LEON CREEK WRC IMPROVEMENTS AND UPGRADES PHASE 2

Solicitation Number: CO-00386

ADDENDUM 3

March 4, 2021

DRAWING NUMBER
10-D121
SHEET NUMBER **110**

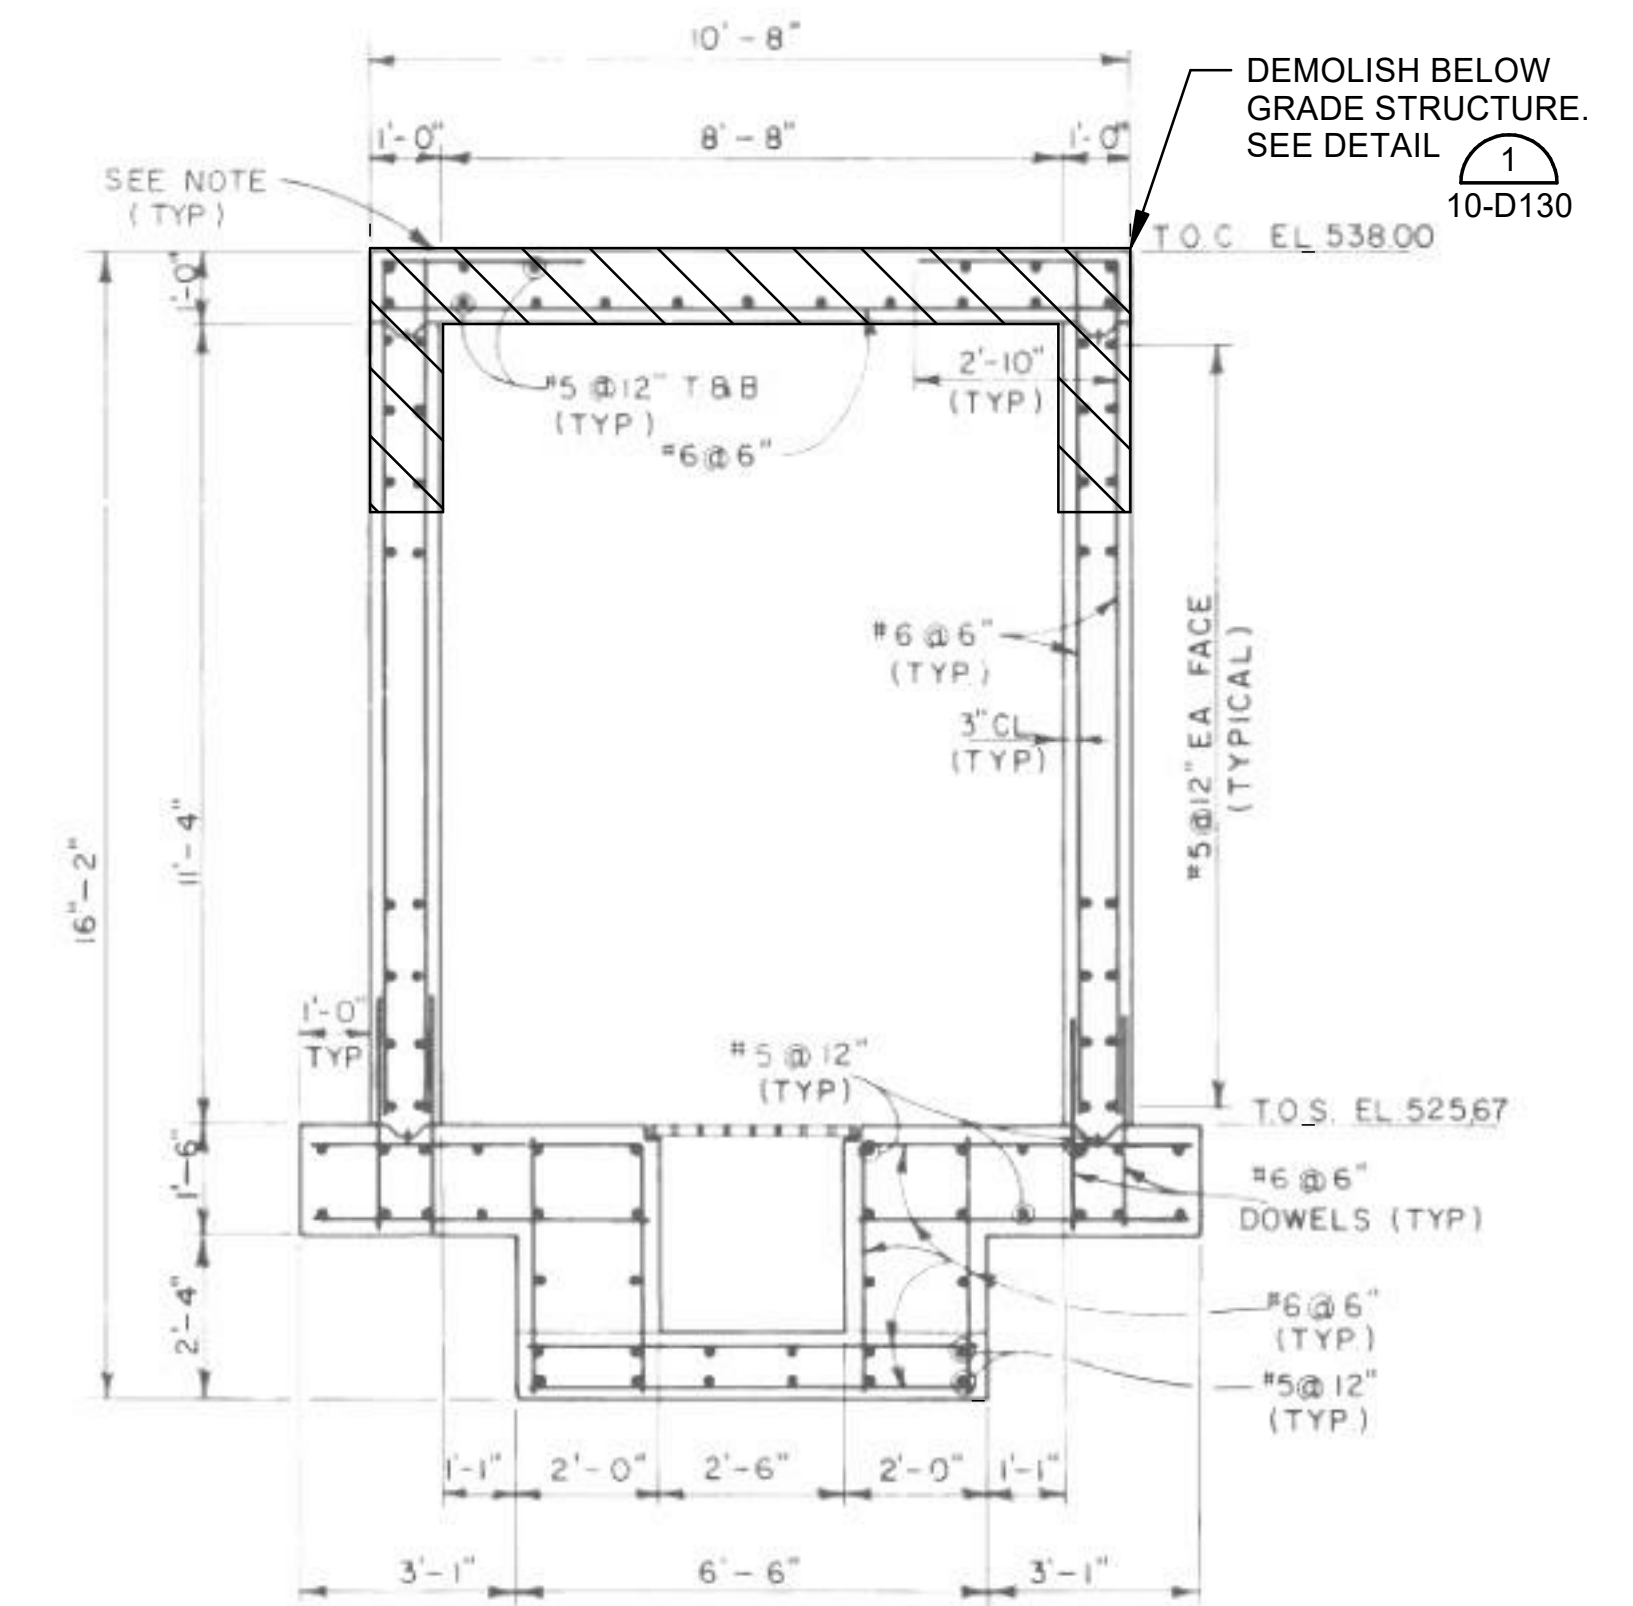
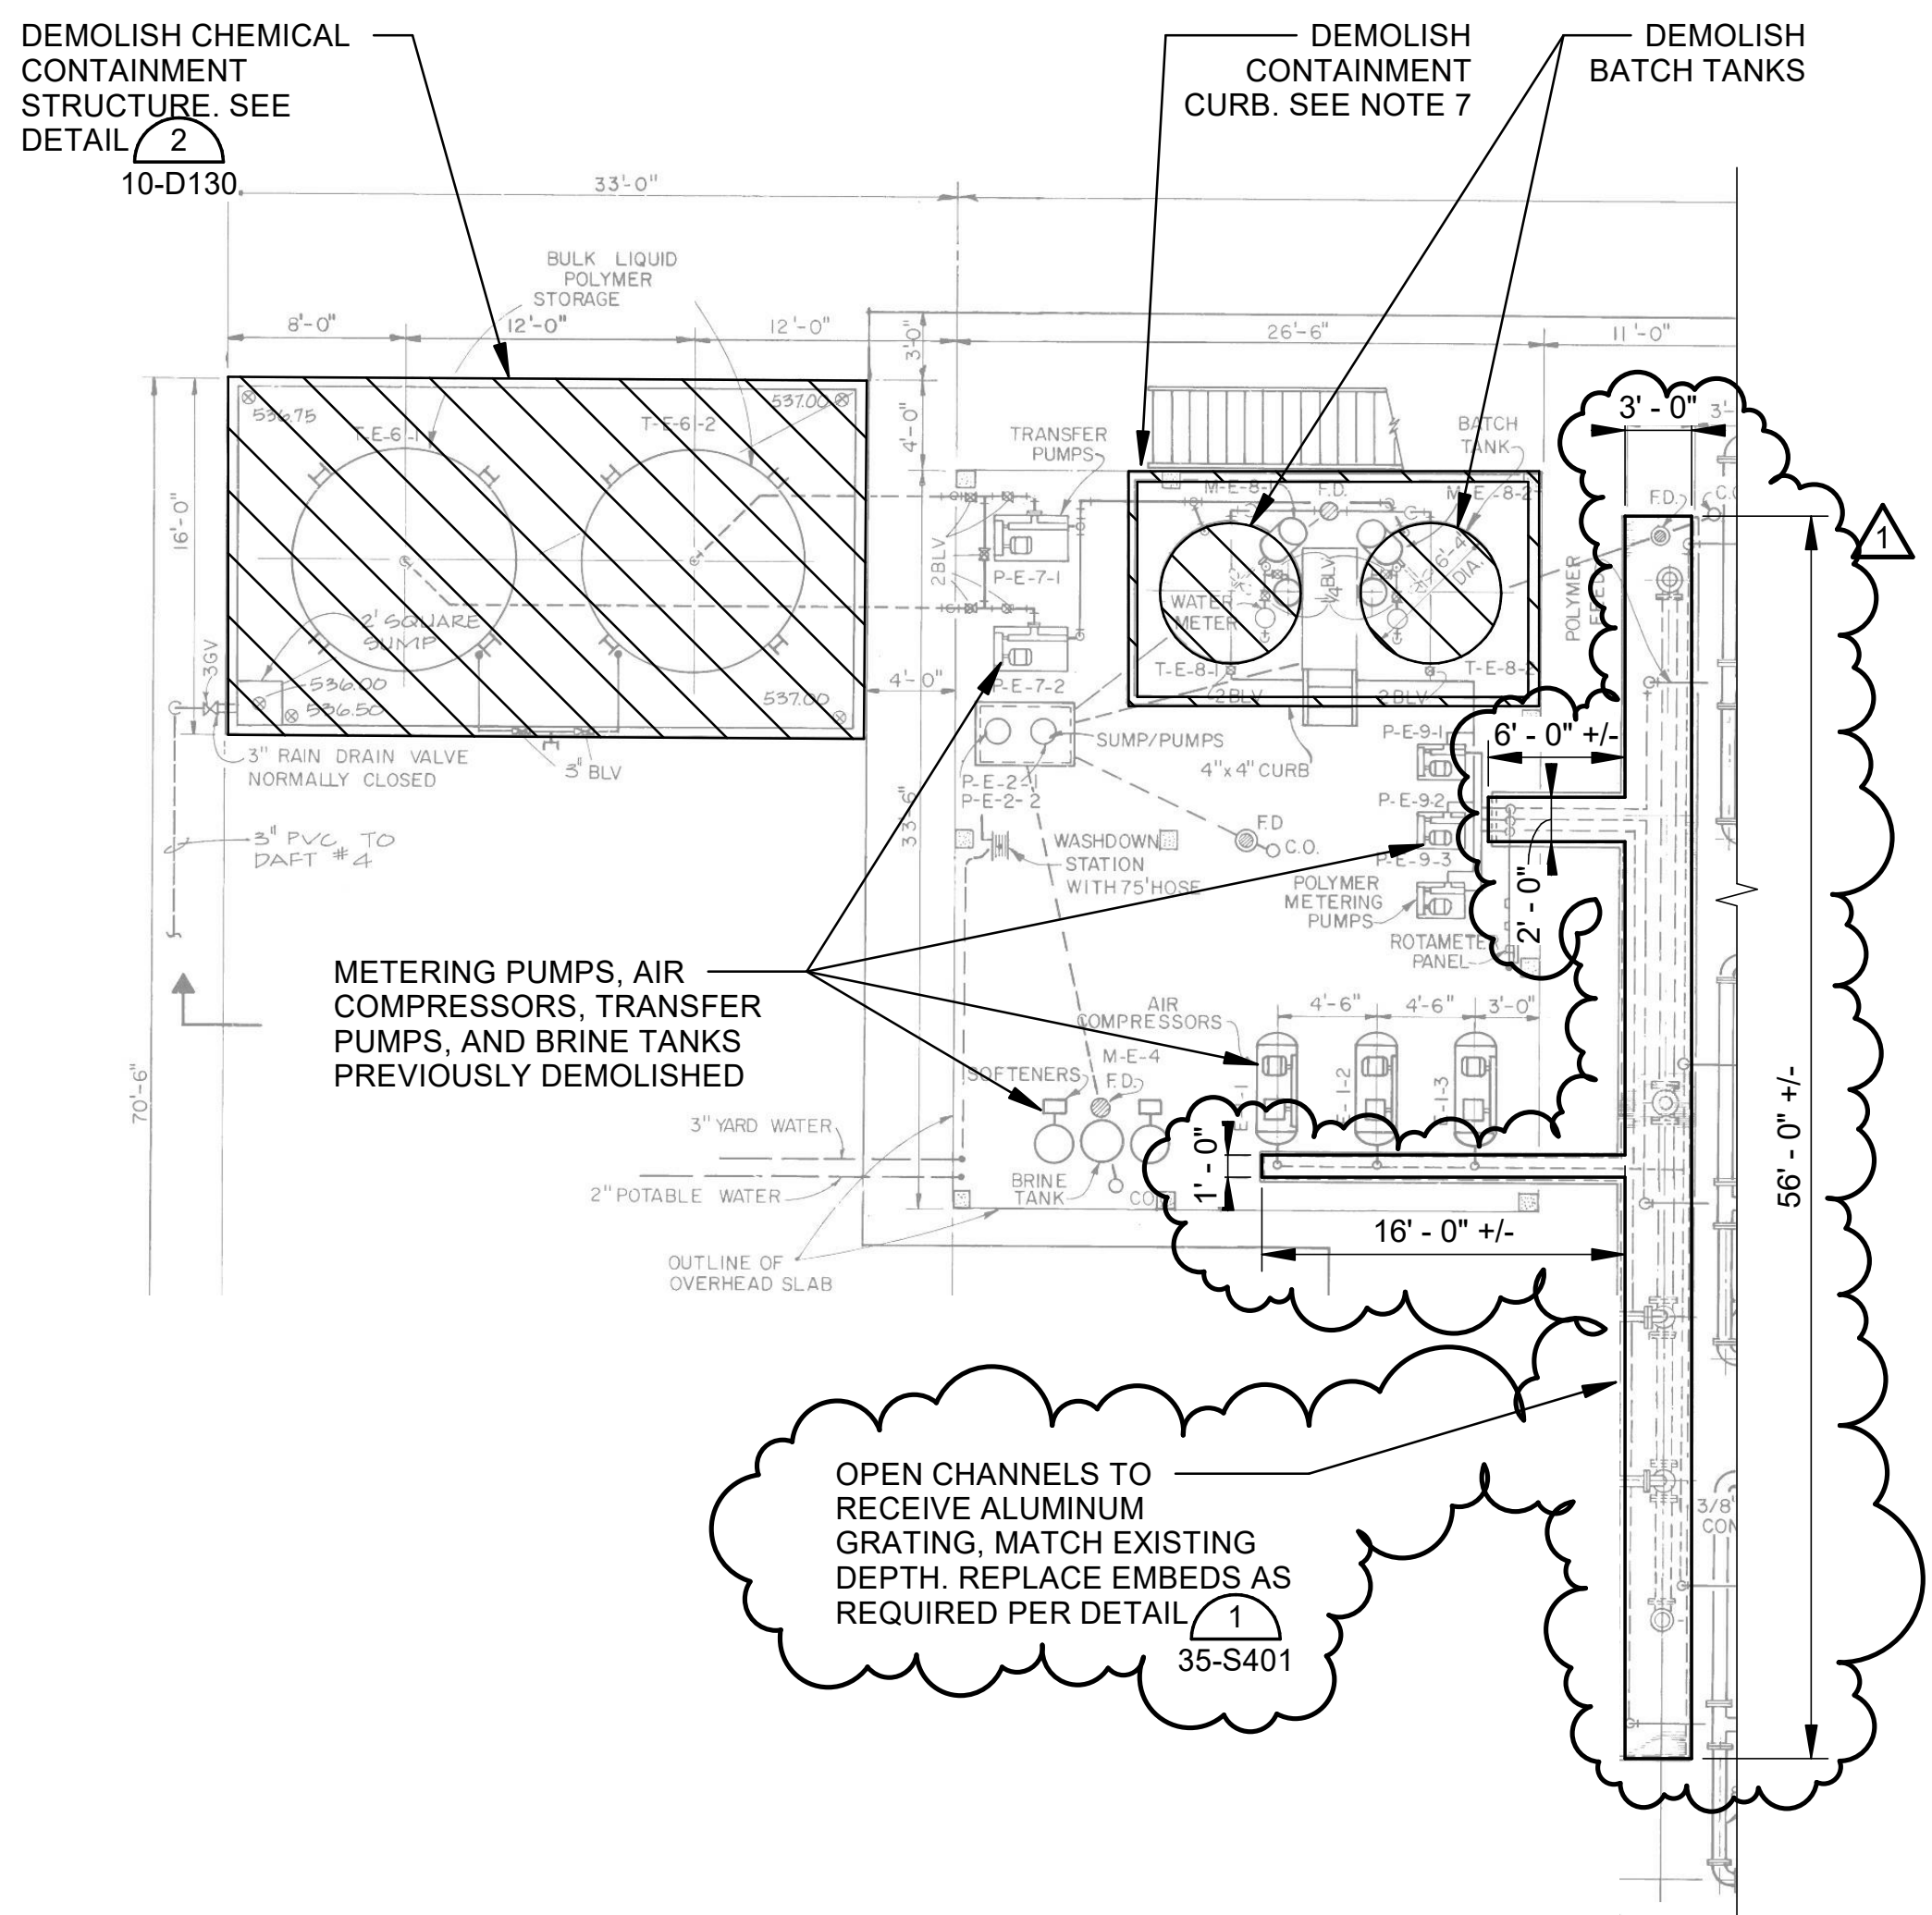
Regarding the demolition of the open-top digesters, it is my understanding that these structures are to be demolished to two feet below existing grade, but it appears the drawings show that the digester walls are demolished all the way down to the slabs on Sheet 10-D121. Please advise.

Can the existing grade elevations around each digester be provided to better determine how much backfill will be needed inside these digesters?

Response: Open-top Digester Nos. 1-7, 9, and 10-12 are to be demolished to two feet below existing grade. All equipment and piping inside the open-top digester structures is to be demolished. Please see No. 3 in the Changes to the Plans portion of this Addendum.

Response: Existing grade ranges from approximately 539 ft to 542 ft. Please see No. 3 in the Changes to the Plans portion of this Addendum.

1. REFER TO GENERAL DEMOLITION NOTES ON SHEET 10-D101.
2. CONTRACTOR SHALL DEMOLISH EXISTING OPEN-TOP DIGESTER TANK NOS. 1-7, 9, 11-12, ASSOCIATED PIPING, TANK FOUNDATIONS, AND STAIRWAYS/PLATFORMS LEADING TO TOP OF TANKS. ACCESS STAIRWAYS AND PLATFORMS LEADING TO OPEN-TOP DIGESTER TANK NOS. 8 AND 10 SHALL REMAIN IN PLACE.
3. CONTRACTOR SHALL DEMOLISH EXISTING TUNNEL EXCEPT FOR PORTION CONNECTING OPEN-TOP DIGESTER TANK NOS. 8 AND 10 (SLUDGE HOLDING TANK NOS. 1 AND 2).
4. FINISHED GRADE RANGES FROM 539.0' +/- TO 542.0' +/- IN THE OPEN-TOP DIGESTER AREA.

BAR IS ONE INCH ON ORIGINAL DRAWING
 IF NOT ONE INCH ON THIS SHEET, ADJUST SCALES ACCORDINGLY.
DRAWING NUMBER 10-D123
SHEET NUMBER 112

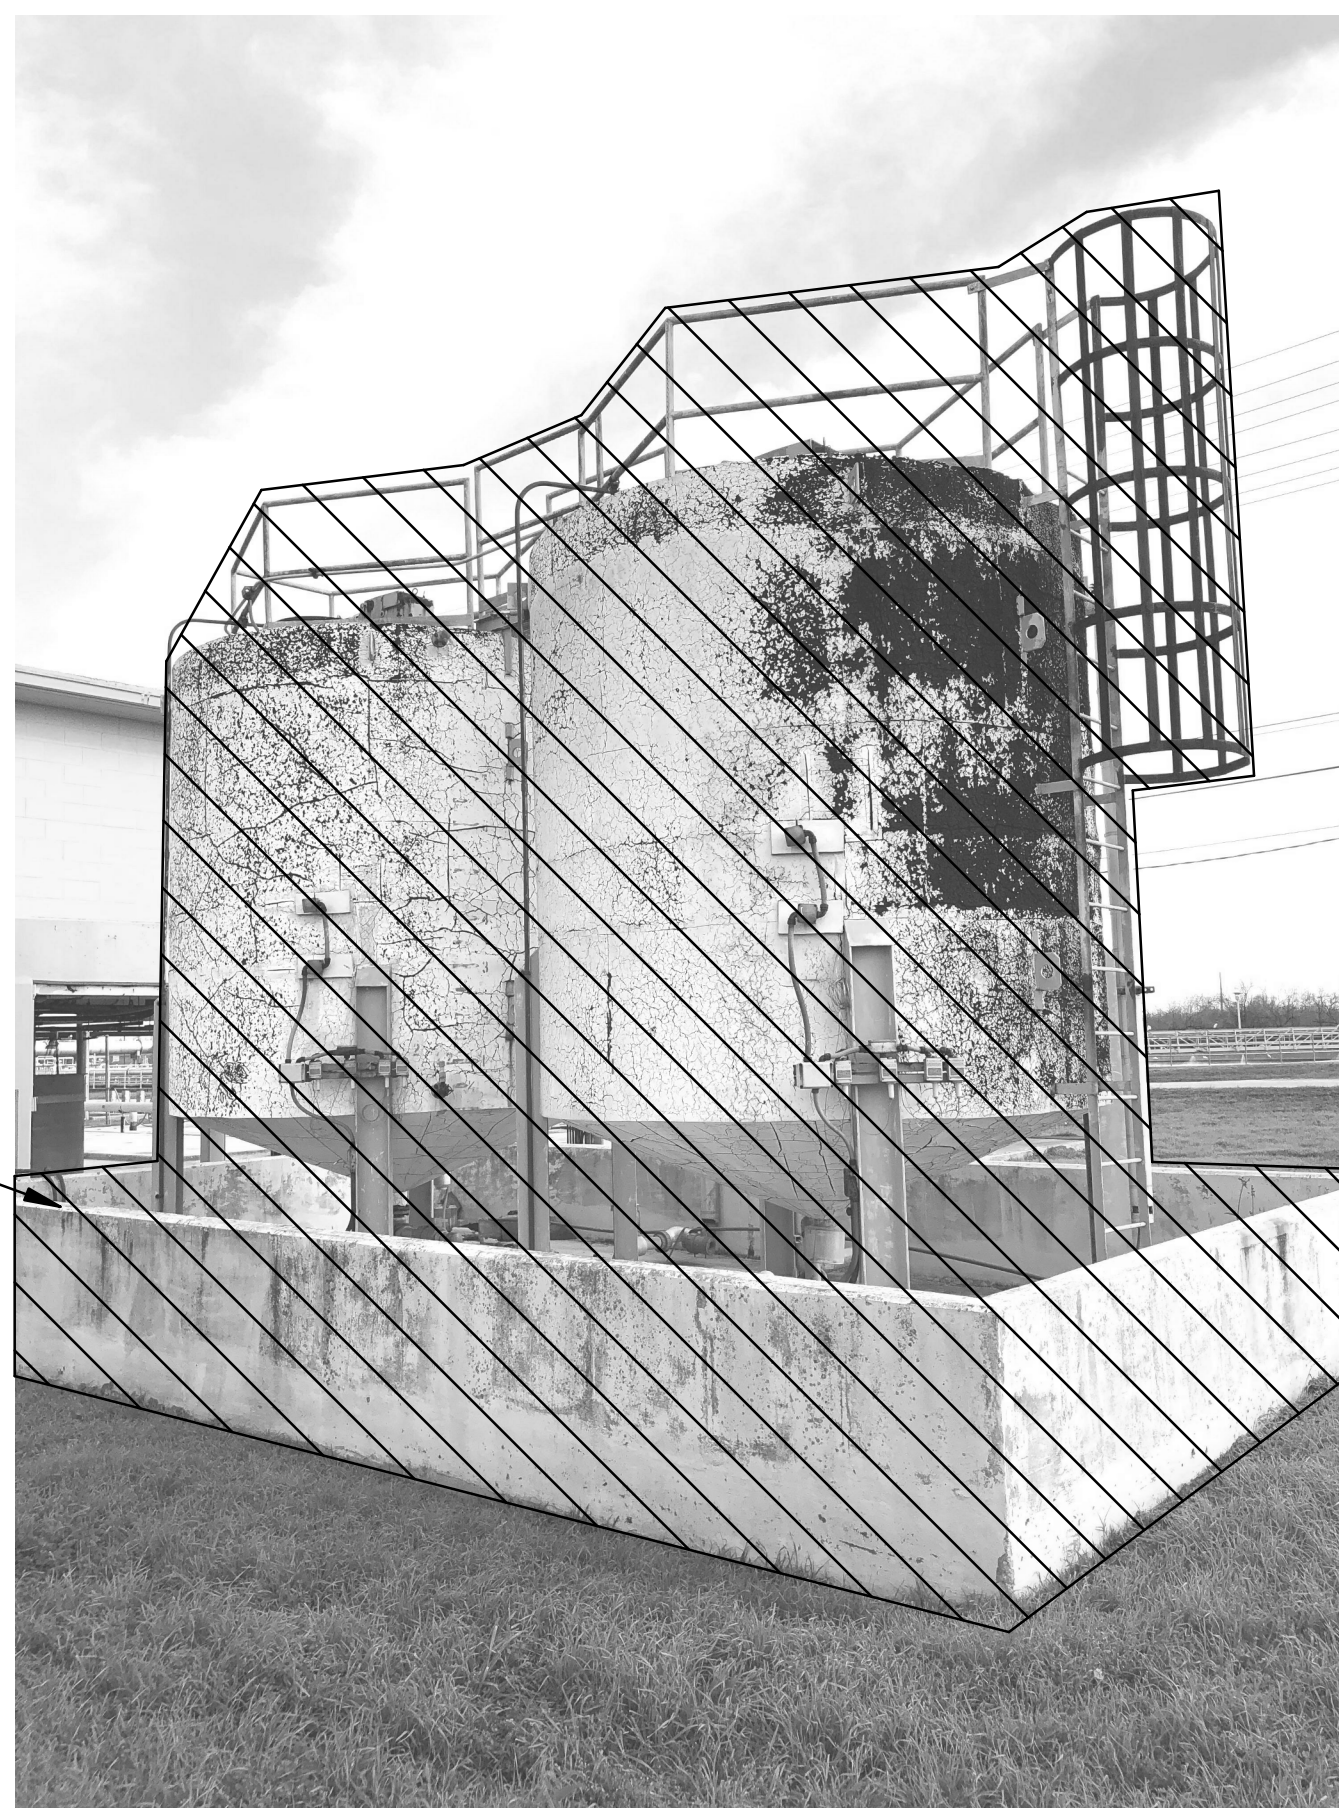
Detail 4/Sheet 10-D123 calls for aluminum grating to be provided at open channels. We have no information as to how much square footage of open channel there is. Please provide more information or a quantity to bid.

Response: Open channel dimensions have been added. Please see No. 4 in the Changes to the Plans portion of this Addendum.
